Re: Revised Procedure
Reconstruction of Slurry Wall
Cap and North Embankment Slope
Pine and Tuscarora Remediation
Site, Niagara Falls, New York

**Reconstruction of Slurry Wall Cap
and North Embankment Slope
Pine and Tuscarora Remediation Site
Niagara Falls, New York**

RESPONSE TO NYSDEC COMMENTS DATED JULY 19, 1990
RECONSTRUCTION OF THE SLURRY WALL
CHARLES GIBSON SITE
NIAGARA COUNTY, NEW YORK

FIGURE 1

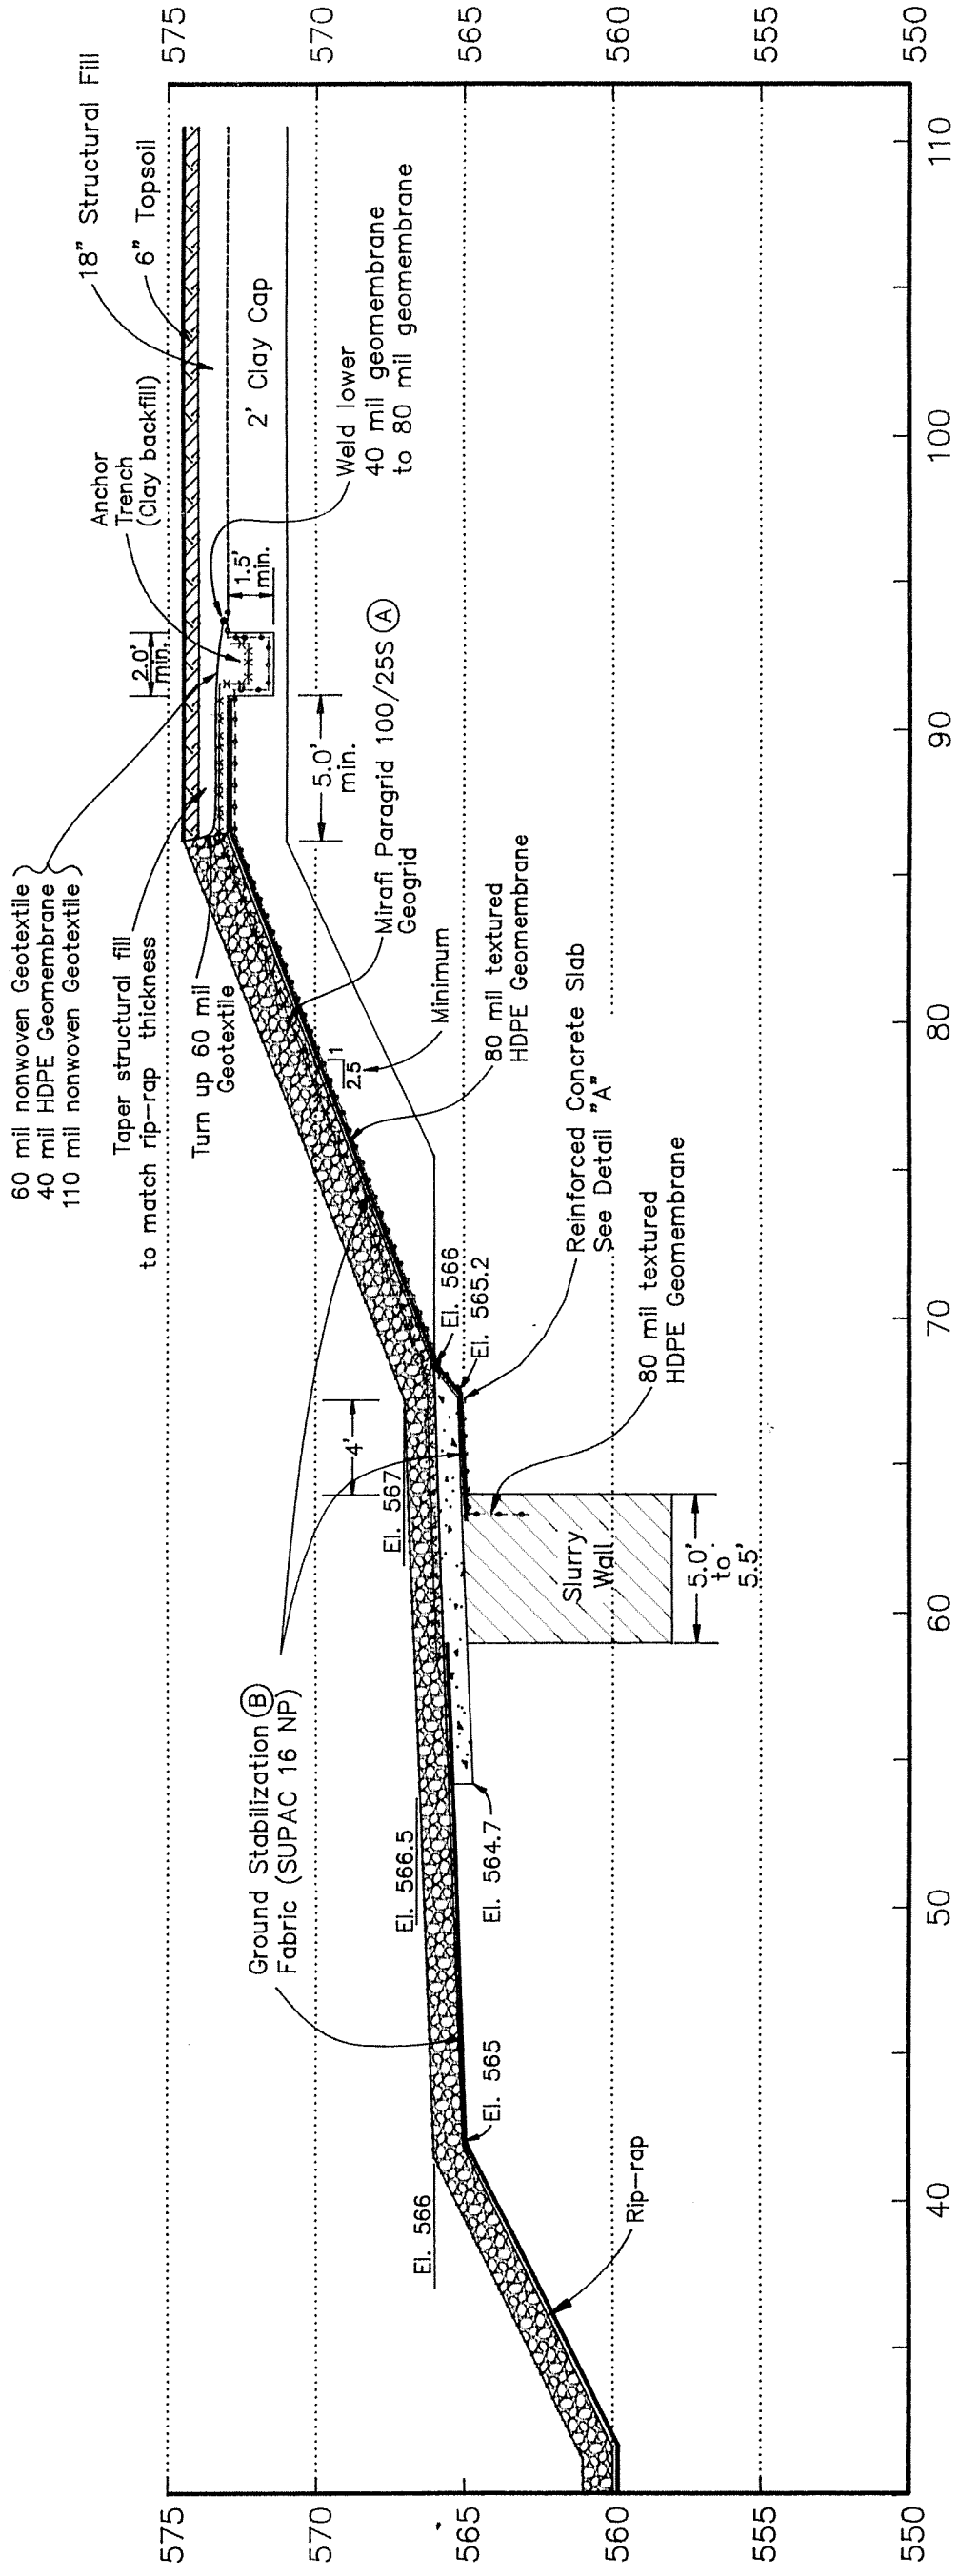
6. Construction of the Remainder of the North Embankment Slope, Item 3, Last Sentence.

The detail for connecting the lower 40-mil geomembrane to the 80-mil geomembrane has been changed by the revised design. The upper edge of the 80-mil geomembrane is buried in an anchor trench 5 feet from the top of slope as shown on the revised Figure 1, and will be welded to the edge of the lower 40-mil geomembrane. The upper 40-mil geomembrane extends horizontally to the top edge of the rip-rap zone.

DEEP-SEATED CIRCULAR ANALYSIS
 PINE & TUSCARORA REMEDIATION SITE

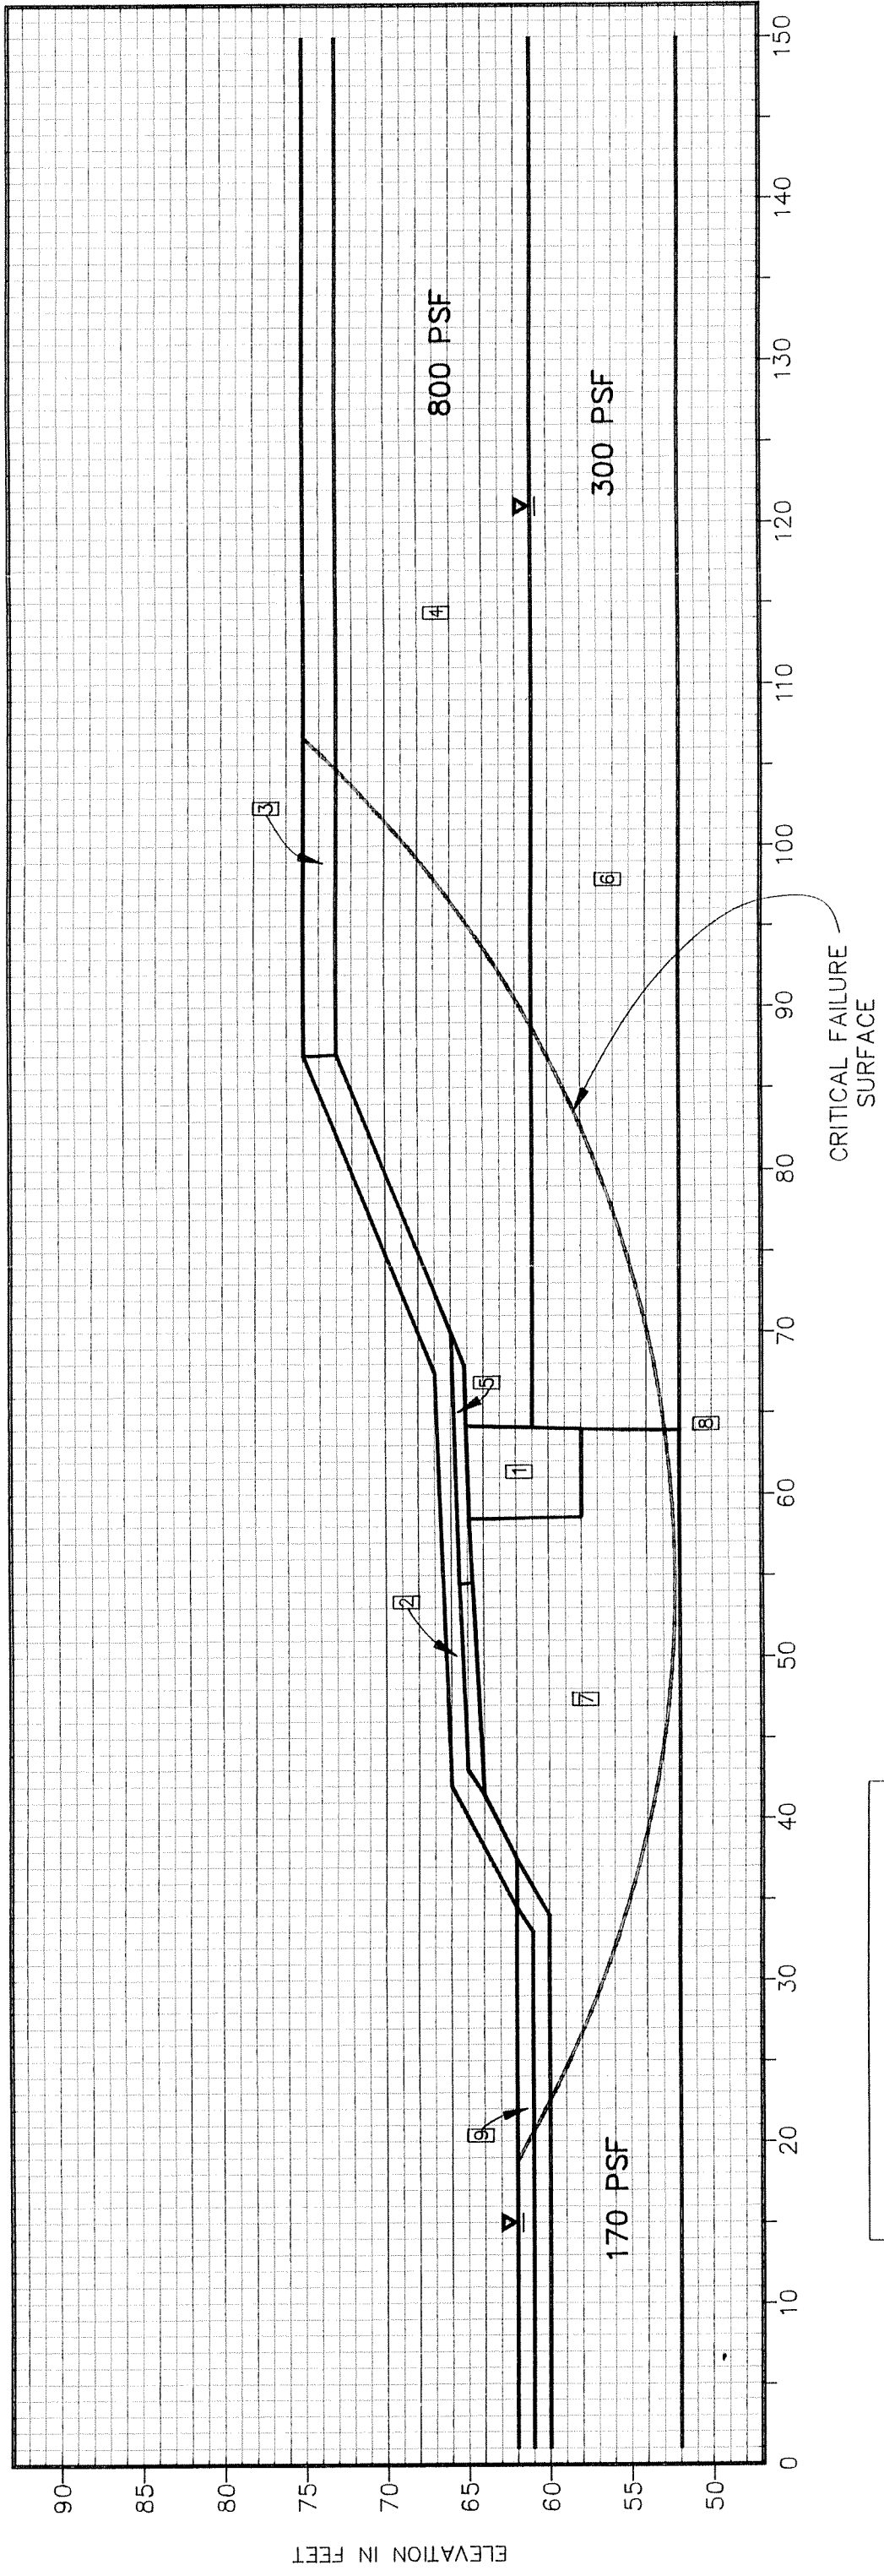
SELECTION OF FAILURE SURFACE

We believe that the failure surface chosen by WCC is the critical failure surface, but it is not too different from the surface proposed by others. As part of this submittal, we have analyzed multiple failure surfaces, including the critical failure as computed by both a circular failure arc and a wedge analysis. We have also analyzed the wedge failure surface that the NYSDEC and their consultants seem to favor, a translation wedge failure through the bottom of the slurry wall. Thus, which failure surface to select is somewhat of a mute point since both have been analyzed for the revised design and they both have acceptable factors of safety.

For additional conservatism, we have also assumed the soft soils on the channel side of the slurry wall to be completely remolded (i.e. $C_r = 170$ psf) and have allowed the computer to search for the critical deep failure circle and wedge analysis failure surface; the resulting factors of safety were computed to be 1.7 and 1.6, respectively. Clearly, this proposed model is ultra-conservative, as the wedge failure through the bottom of the slurry wall is far more likely. It is WCC's opinion that these calculations confirm that the proposed embankment can be constructed with an adequate end-of-construction (short-term) and long-term factor of safety against future slope failures.

Subject: Sliding Wedge Analysis Sheet 1 of 3
Hydraulic Loading from Job No: 89 C 2857
Slurry Wall Pine and Tuscarora Site

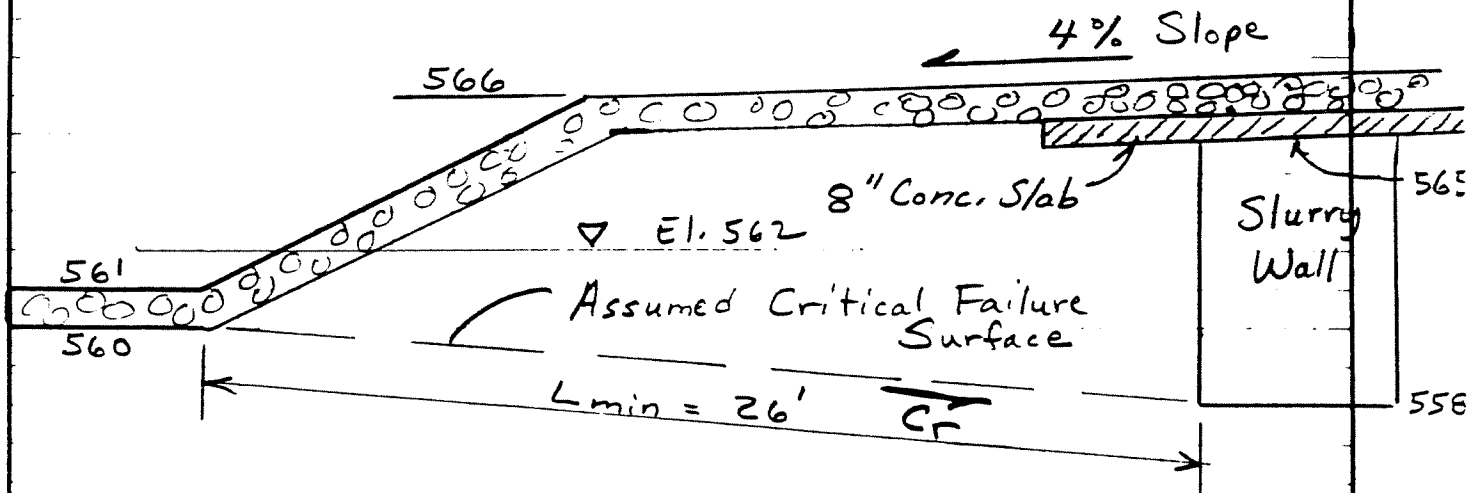
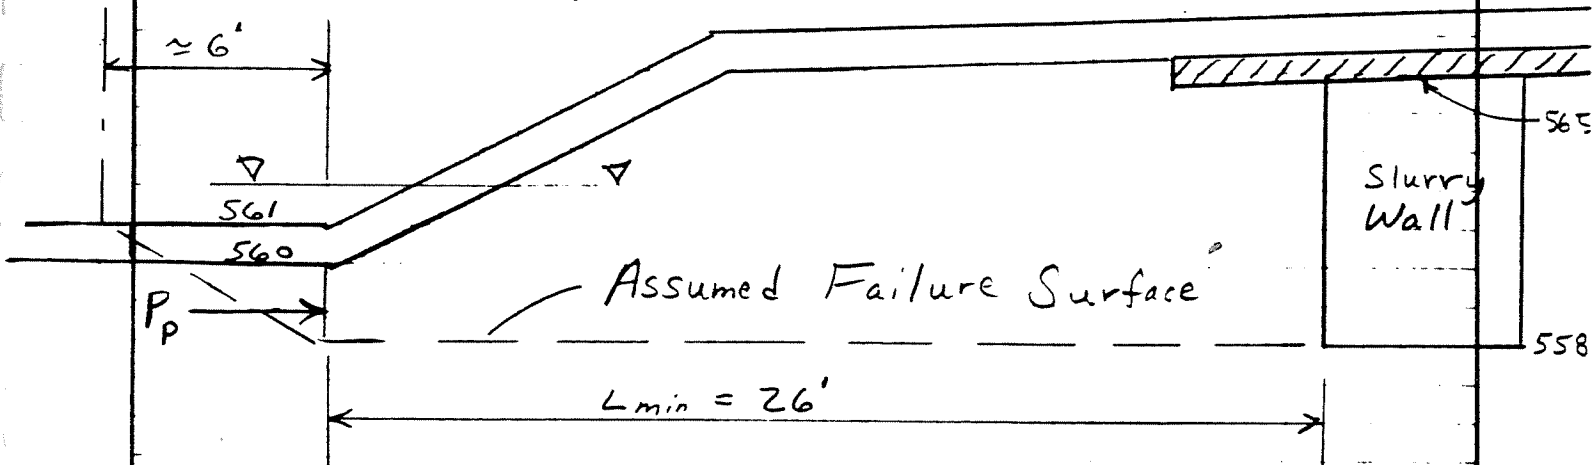
SHEAR STRENGTH REDUCTIONS

Provided that no additional load is applied to the top of the slurry wall, the FOS against a "local" wedge failure is likely to be ≈ 2.0 ; assuming an ultra-conservative $C_r = 100 \text{ psf}$ (which WCC considers to be highly unlikely), the FOS is 1.2 for WCC failure surface and 1.4 for the NYSDEC failure surface (w/ passive toe wedge).

Recognizing NYSDEC's concerns with our strength reduction approach, we have included a parametric study in the revised calculations to determine the factor of safety as a function of the residual shear strength (C_r). These calculations indicate for the postulated failure surface, which passes through the bottom of the slurry wall and exits in the bottom of the channel as a wedge failure, would have a factor of safety of 1.3 for a residual shear strength as low as $C_r = 90$ psf. It is WCC's opinion that the residual shear strength is at least as high as this value and more likely in the range of 170 psf, which gives a factor of safety of 2.0 to 2.4, depending which postulated failure plane is used.
